RFI/FIELD DESIGN CHANGE/DESIGN DIRECTIVE

RFI Number (from Walsh): 00070 **Date:** 7/20/11

Drawing Package Title: Various Bridges

SECTION THRU ABUTMENT SEAT

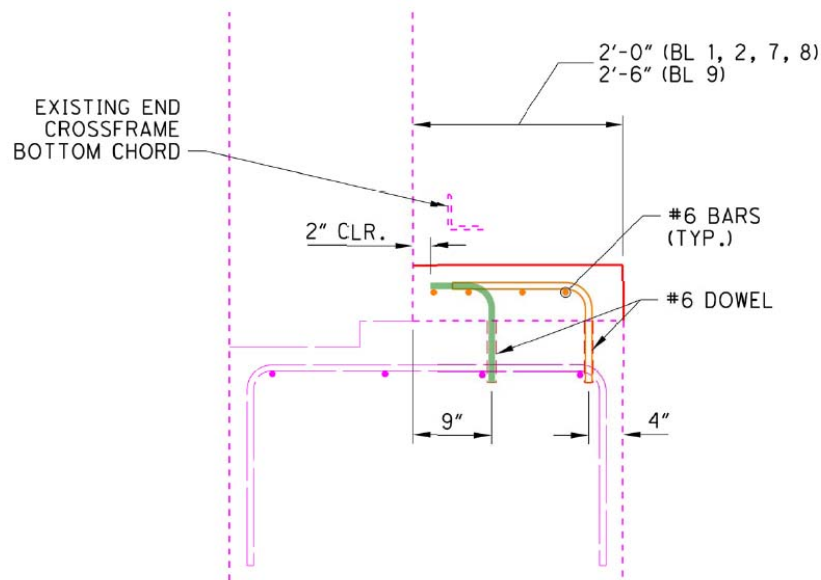
Description of Change: On bridges 1, 2, 7, 8, 9, due to the end cross frames conflicting with per plan dowel locations on the abutment extensions and seismic pedestals, we cannot drill and install the dowels in the required locations.

Requested Change: Walsh would like to drill and install the dowels approx. 8" from the back walls directly next to the end cross frame. We understand that there may be a need to eliminate bars or adjust "L bar" tail lengths to make this work.

Response: HNTB recognizes the challenge of installing the dowels beneath the bottom chord of the existing end crossframes remaining and proposes the following alternate details for both the abutment beam seat and seismic pedestal reinforcement.

*Abutment Beam Seat Reinforcement:
(BL 1, 2, 7, 8 & 9)*
